Points for Upland Contracting Ltd. Mine Plan Comment Letter:

Re: Upland Contracting Ltd. Mine Plan Application G-8-114, located at 7925 and 7311 Gold River Highway, in Campbell River, British Columbia.

FIGURE 4.1

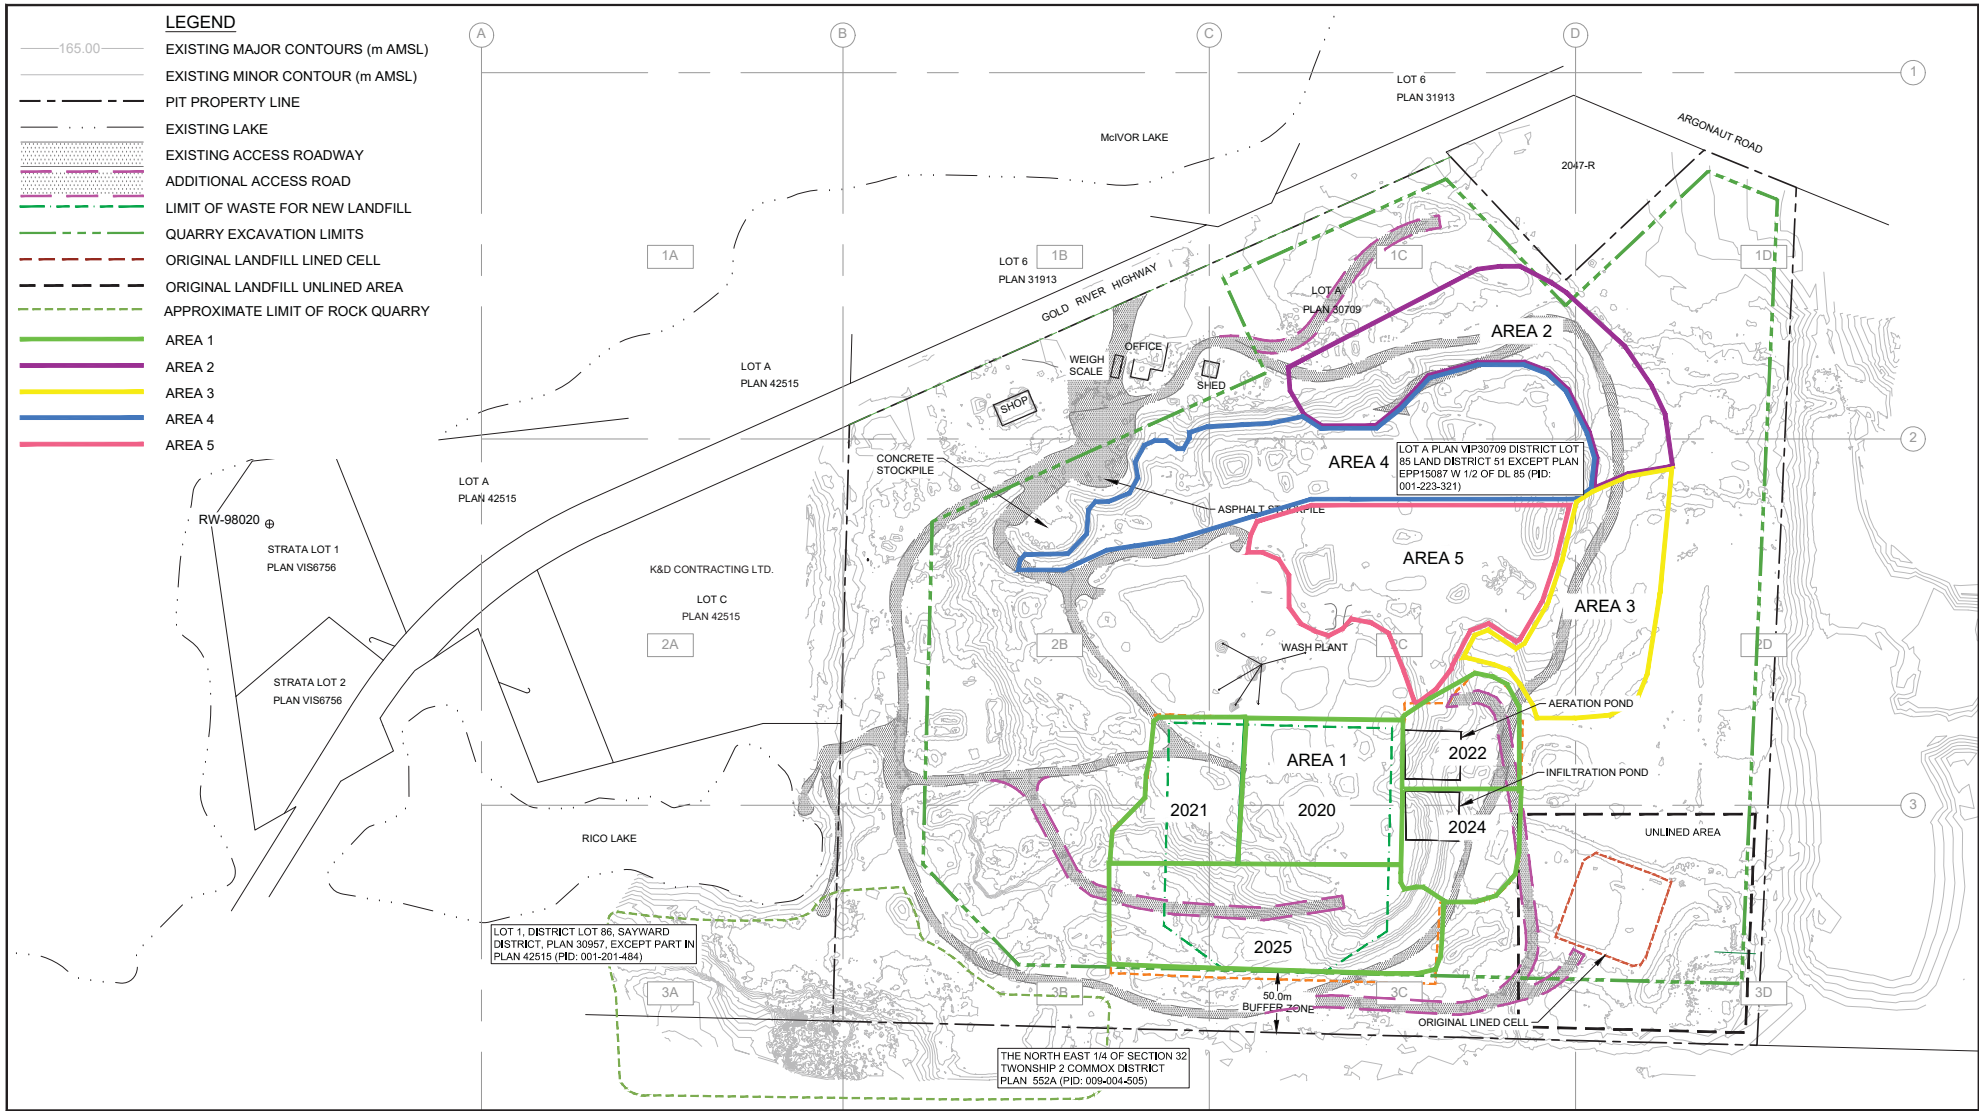
1. The mine plan Rock Quarry in the green dotted line in Figure 4.1 attached is located above Rico Lake.

6. Upland Contracting Ltd. needs to provide groundwater elevation in mine plan areas listed below:

Area 2, Area 5, Area 1-2021, Area 1-2022, Area 1-202. Groundwater elevation is also not provided for the original landfill and the western and southwestern bedrock ridge.
